**LEE'S SUMMIT**  
MISSOURI  
Development Services Department

## Development Services Staff Report

<b>File Number</b>	PL2024-073
<b>File Name</b>	PRELIMINARY DEVELOPMENT PLAN – Cobey Creek
<b>Applicant</b>	Clayton Properties Group
<b>Location</b>	500 SE M 150 Hwy
<b>Planning Commission Date Heard by</b>	May 23, 2024 Planning Commission and City Council
<b>Analyst</b>	C. Shannon McGuire, Planning Manager

Figure 6 – Proposed housing type site plan

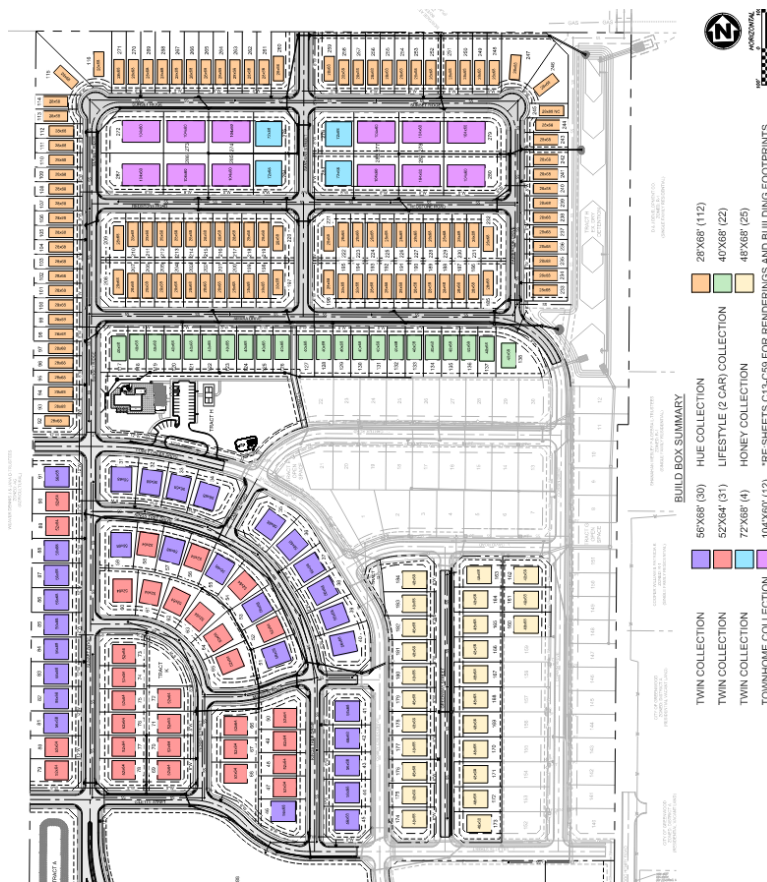
The proposed narrower lots and quadplexes are situated so that they are all located in the northern portion of the development. The layout of the proposed duplexes are in the same general location as the duplexes that were previously approved. The proposed layout provides a stepped approach from the lower density single-family and duplex products to the higher density narrow lot single-family and quad plex products being offered.
